1. In considering the suitability of the site for the development when preparing the current proposal, what design and location options were considered by the Applicant and when and why were they each rejected in favour of the current proposal? In detailing the design and location options demonstrate consideration of:

The applicant's team presented six (6) different options to Council for the upgrades to the Newport SLSC (trim: 2020/105669). Those options are described by the Coastal Engineer as below (presentation in trim link):

Figure 1: Contiguous piles with plug piles (example from Collaroy-Narrabeen Beach private coastal protection works tender documentation)

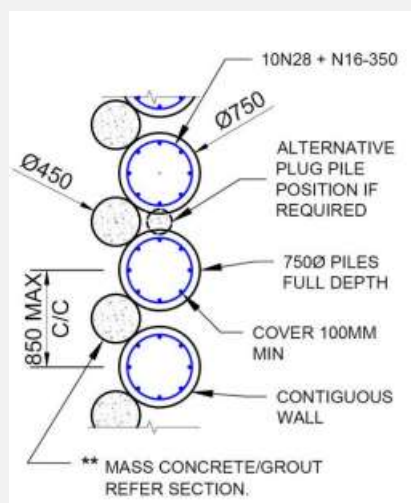
6. Confirm that Secant not Contiguous piles are to be used. Address the unknowns in the reference notes to Dwg S02 Rev D by Horton. (Notes 3 And 4).

Secant piles are proposed. Contiguous piles with plug piles (see example in Figure 1) achieve a similar continuous barrier to migration of soil and may also be considered if this suits the

contractor's methodology, and this methodology satisfies the Principal's structural, coastal and geotechnical engineers. Neither option is necessarily better or worse, and they can both achieve the same outcome of a continuous barrier.
